City of Portland, Maine - Building or Use Permit Application

Permit No: 04-0448	Issue Date:	CBL: 088 M006001
-----------------------	-------------	---------------------

Past Use: vacant land	Proposed Use: Single Family: 30' x 30' one story dwelling on posts	Permit Fee: \$1,086.00	Cost of Work: \$110,000.00	CEO District: 1
		FIRE DEPT: <input type="checkbox"/> Approved <input checked="" type="checkbox"/> Denied <i>N/A</i>	INSPECTION: Use Group: R-3 Type: 5B BOCA 1999

RE: 225 Brackett Avenue, Peaks Island
(ID # 2004-0080, CBL #088M006)

STAIR DETAILS

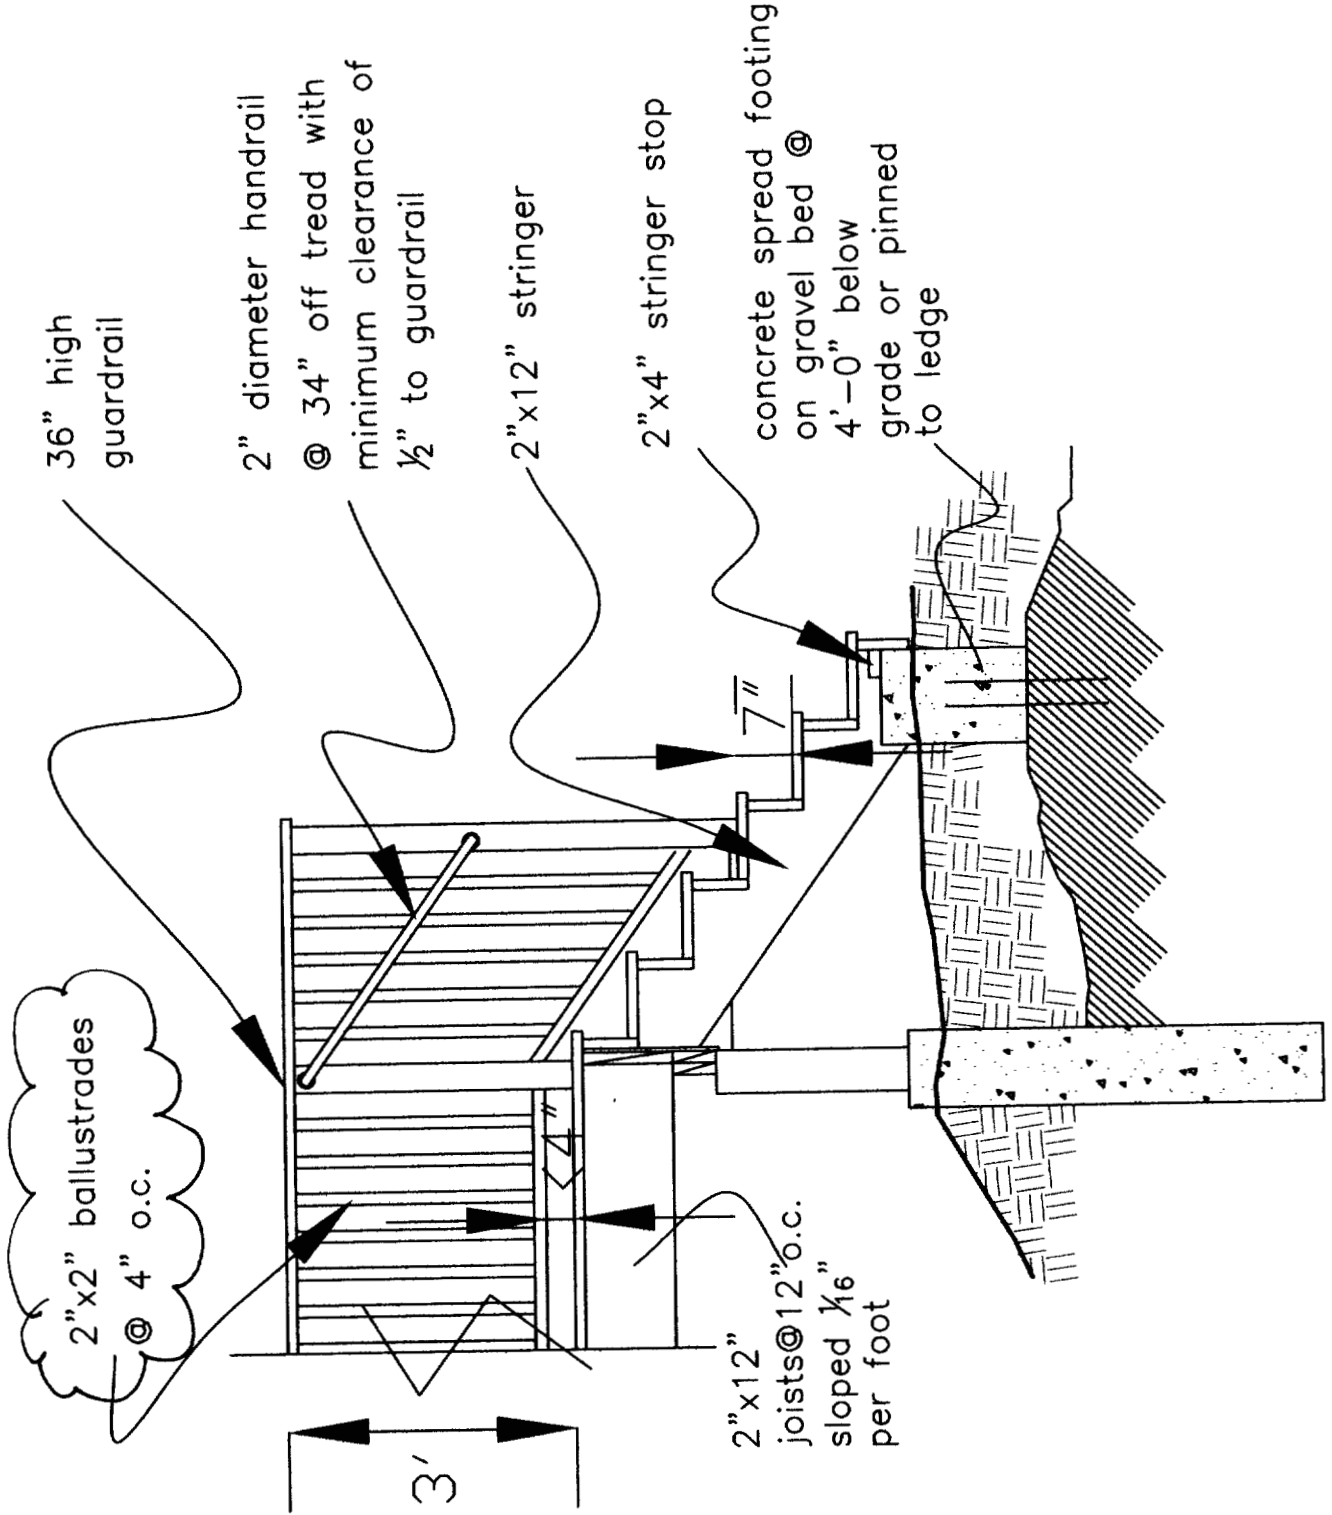
Header Schedule	Type of Heating System	Number of Stairways	Interior	Exterior	Treads and Risers (Section 314)	Width	Headroom	Guardrails and Handrails (Section 315)	Smoke Detectors Location and type/Interconnected	Plan Reviewer Signature	See Chimney Summary Checklist
Renna					7" R / 11" T	4'	OK	OK Shows horizontal balusters	Not allowed under BCAA.	OK	See Chimney Summary Checklist

- 1 balustrade revision, permit submission page fifteen
- 2 joist span revision of entry porch, permit submission page nine
- 3 egress window revision, permit submission page two (also, please see revised window schedule)
- 4 safety glazing revision, permit submission page two (also, please see revised window schedule)

FIRST FLOOR PLAN

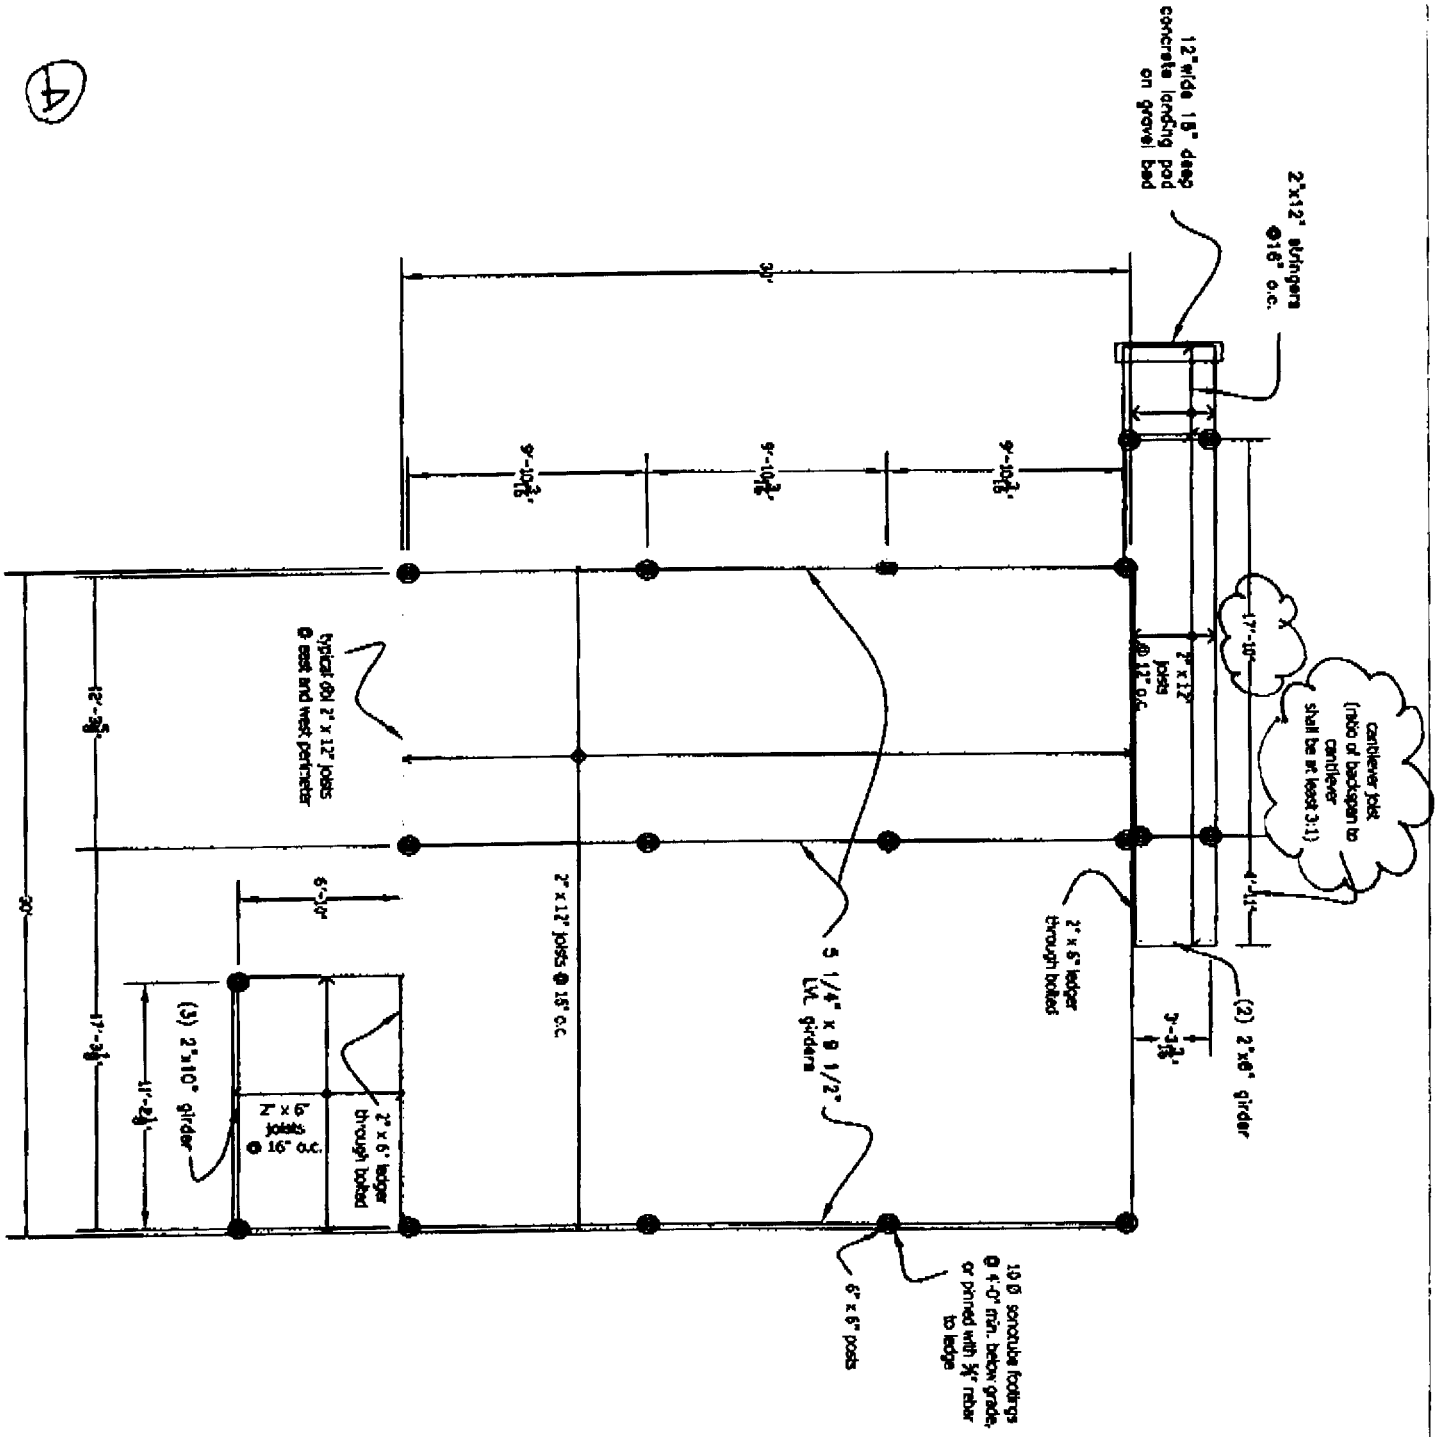
- 1) If the egress windows in the bedrooms are casement windows, egress hardware must be installed on them.
